ZONING ADMINISTRATOR MEETING AGENDA

PUBLIC HEARING**2. SC24-0006 – Narinder Paul – 1501 Oakley Drive**

SUBMITTAL OF PLANNING APPROVAL FOR
PAUL RESIDENCE
1501 OAKLEY DRIVE
LOS ALTOS, CA 94024
APN:318-10-025

CS-1.0

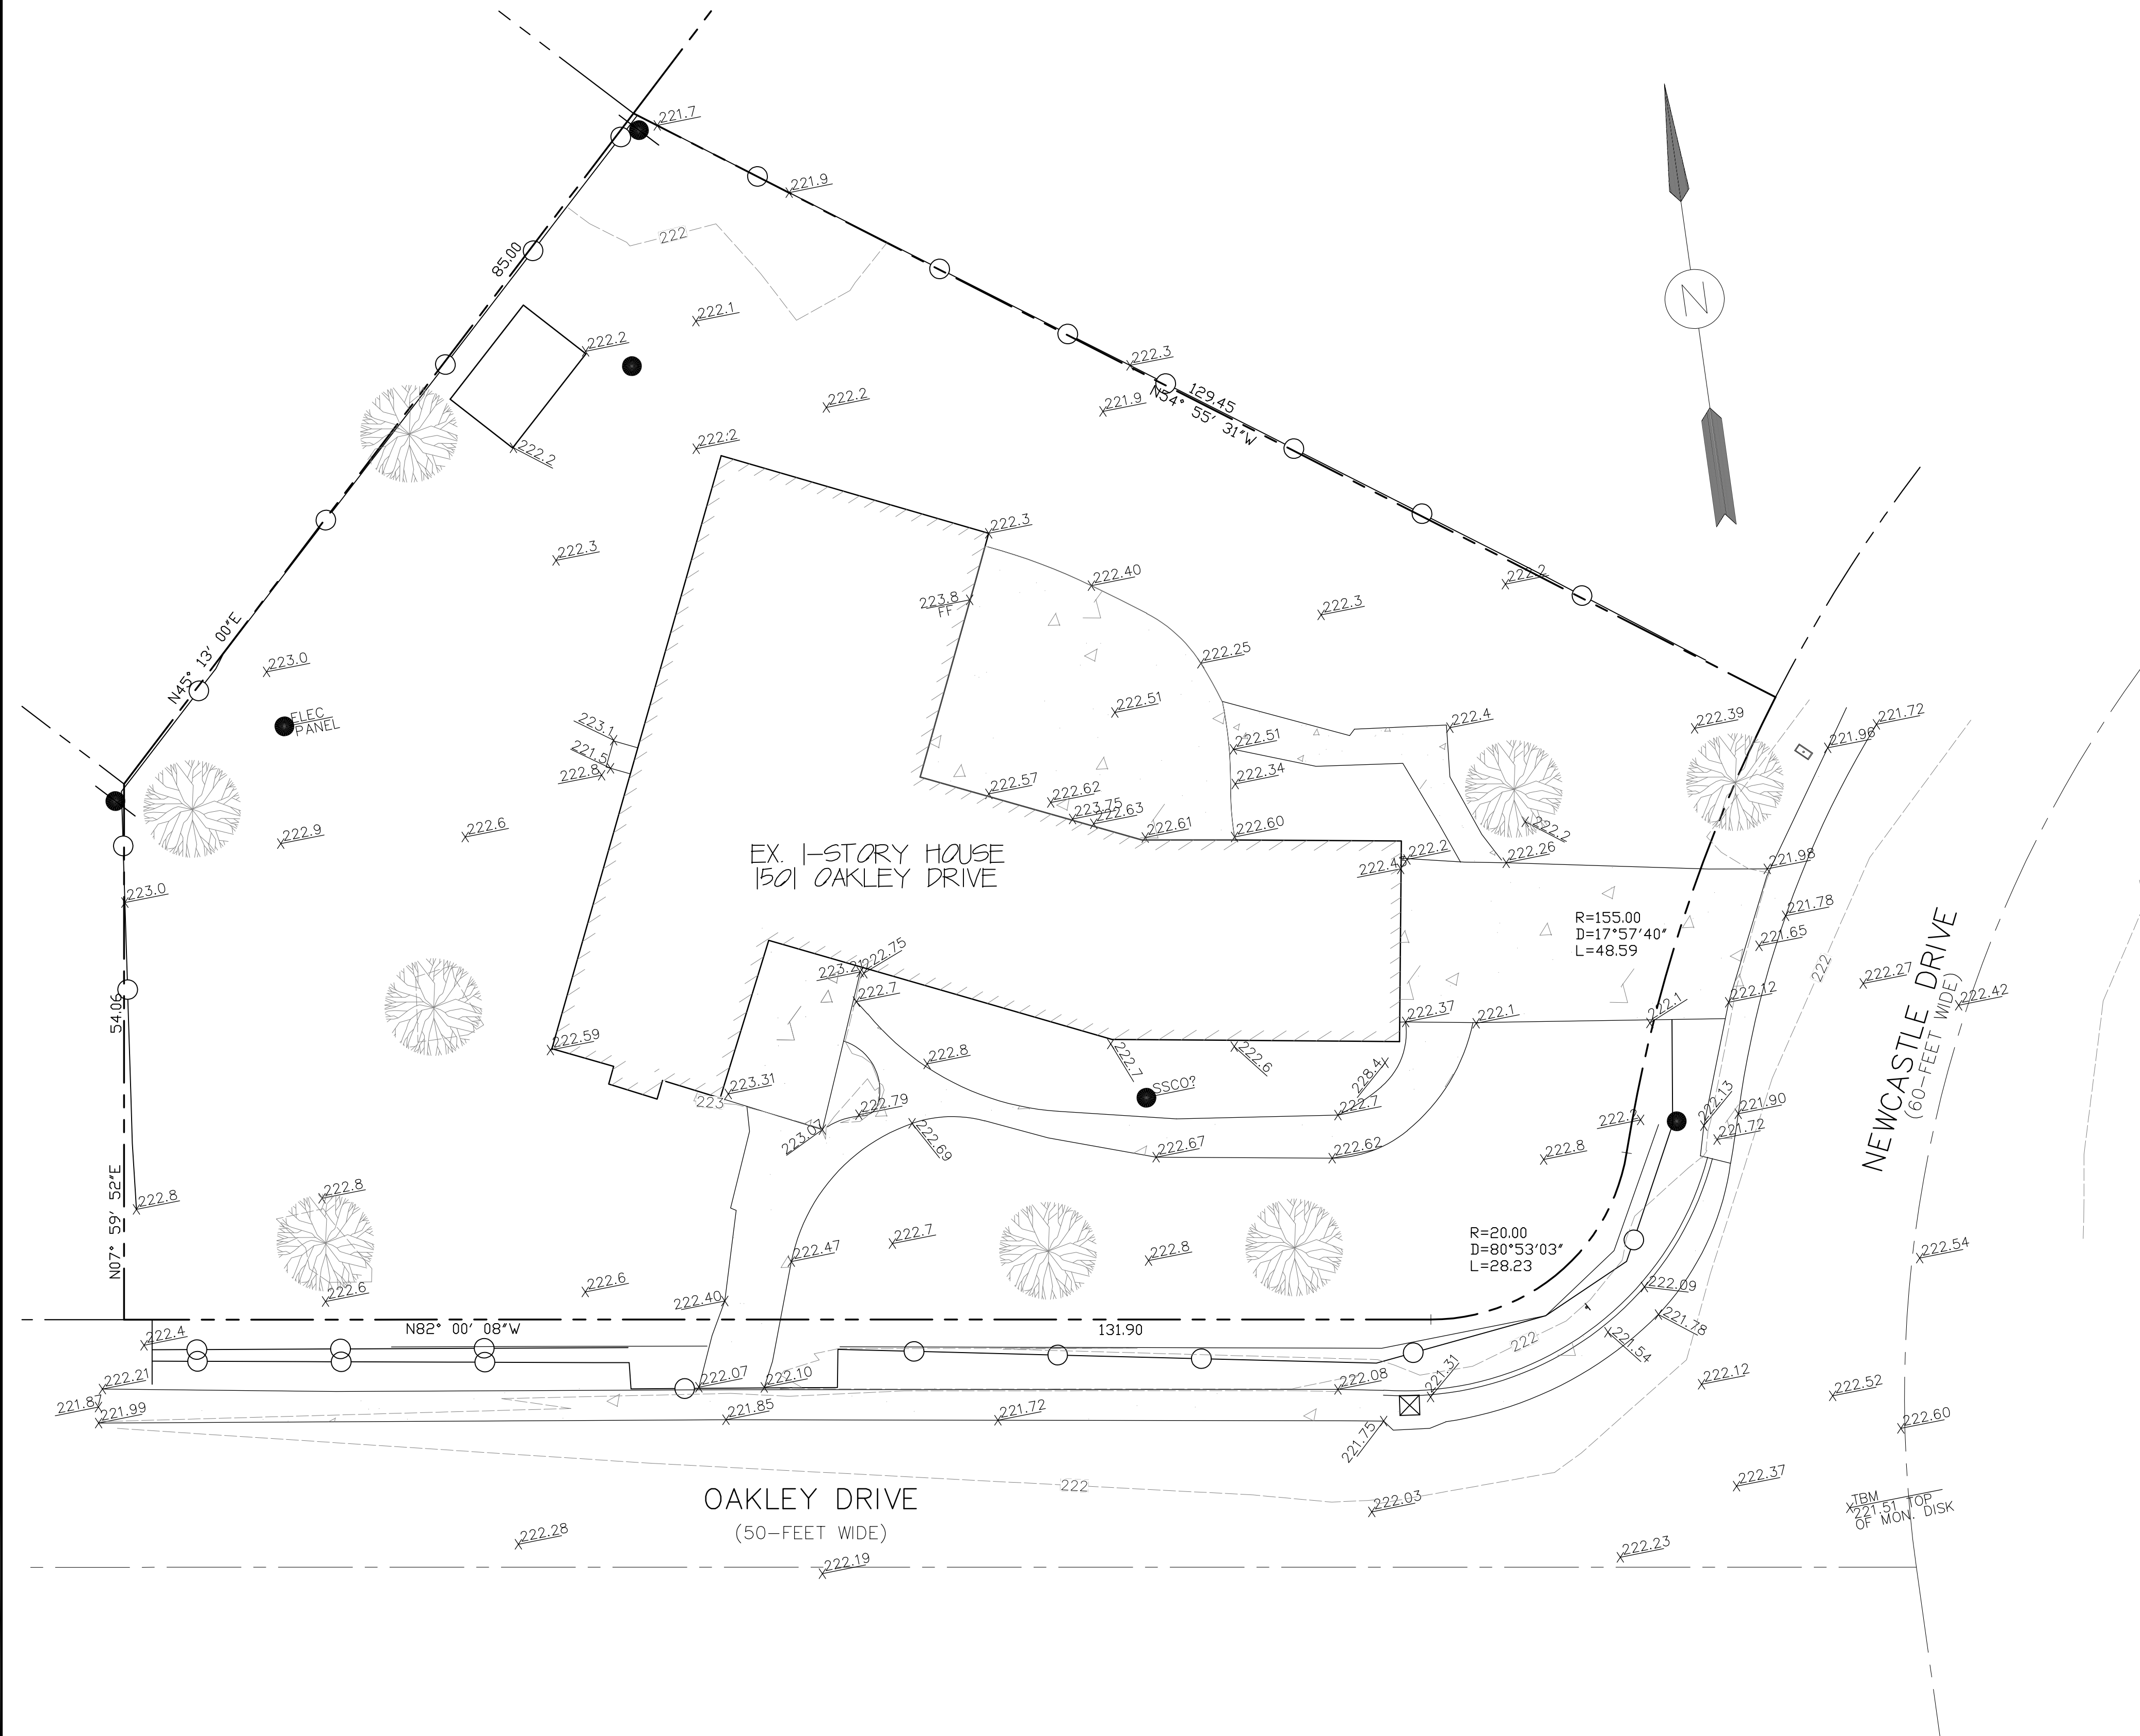
- d. On the Cover Sheet Zoning Compliance Table:
 - i. Correct the habitable and nonhabitable square footages by switching the Change In and Total Proposed areas.

- ii. Revise the proposed and required setbacks to provide consistency with the approved plans.
7. **ADU Not Reviewed:** The proposed ADU included in the plan set is not part of this design review application. Prior to commencement of the ADU construction, a separate building permit issued by the Building Division shall be obtained.

SHEET NO.
C-4.0

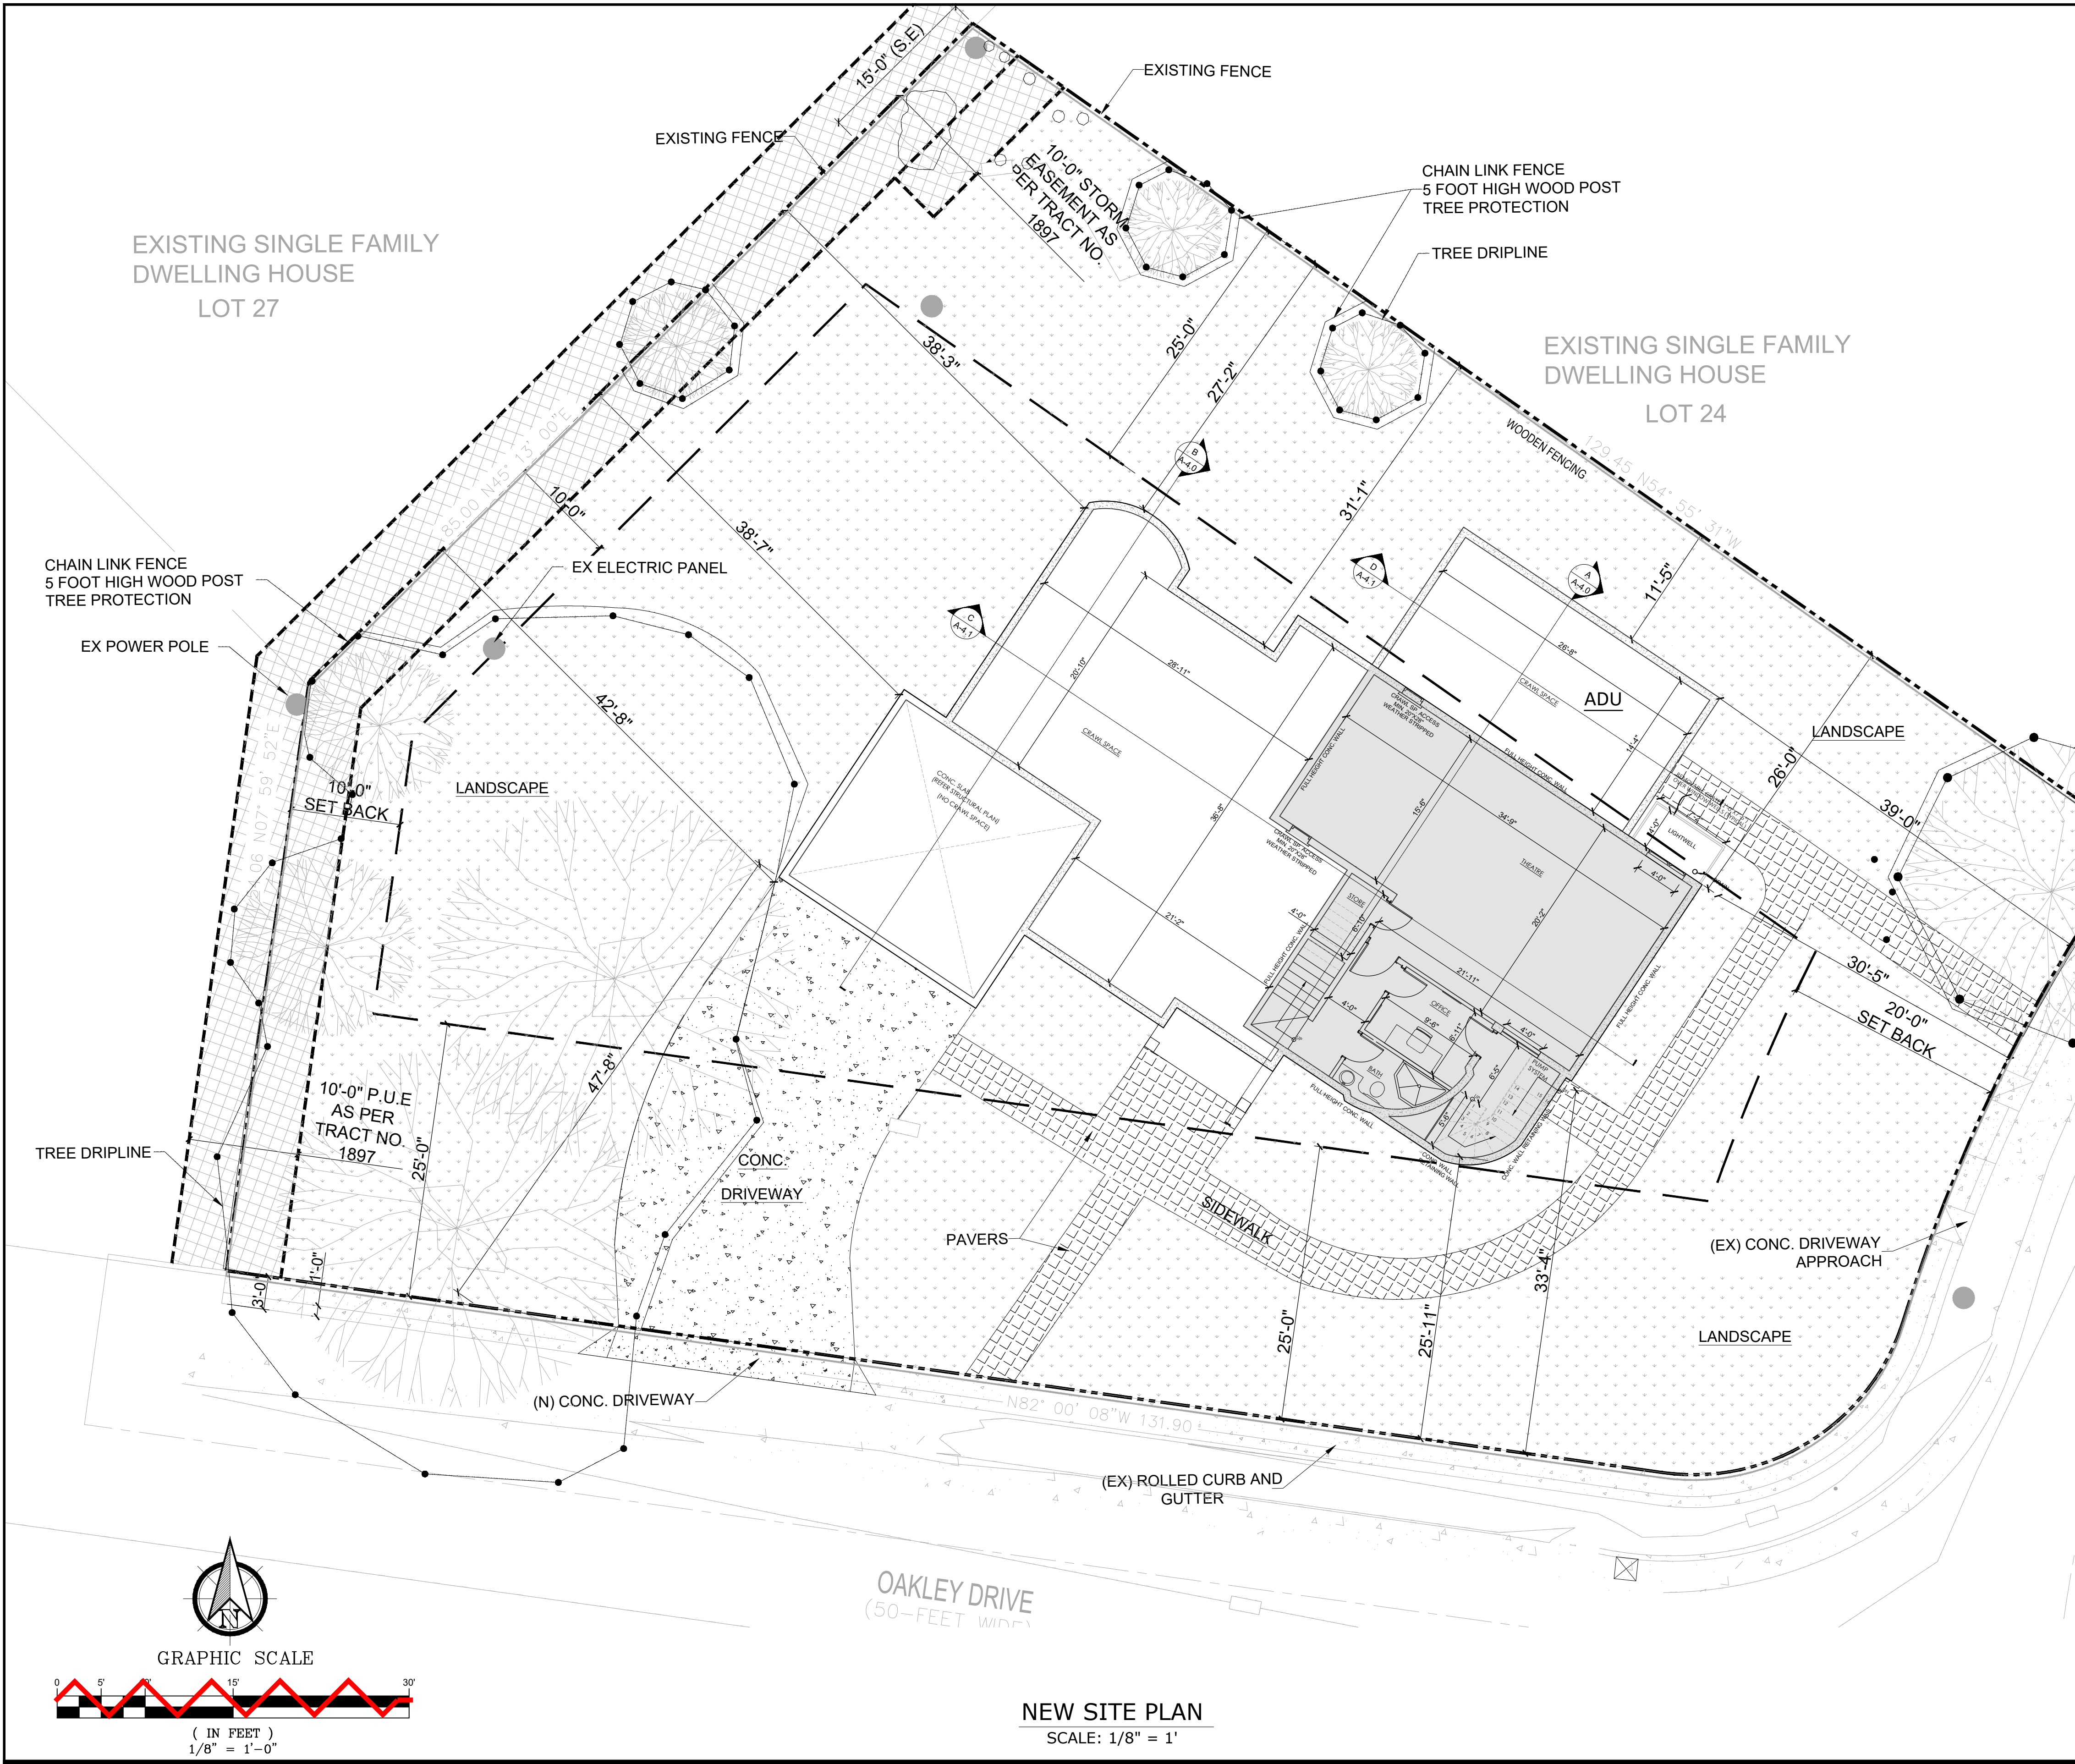
- a. On C-4.0-C-4.2 remove or correct the scale bars indicating 10 scale.
 - b. On the Basement Site Plan add dimensions to indicate the basement exterior facade lengths and demonstrate light well widths comply or revise the plans as necessary to reduce the width for compliance.
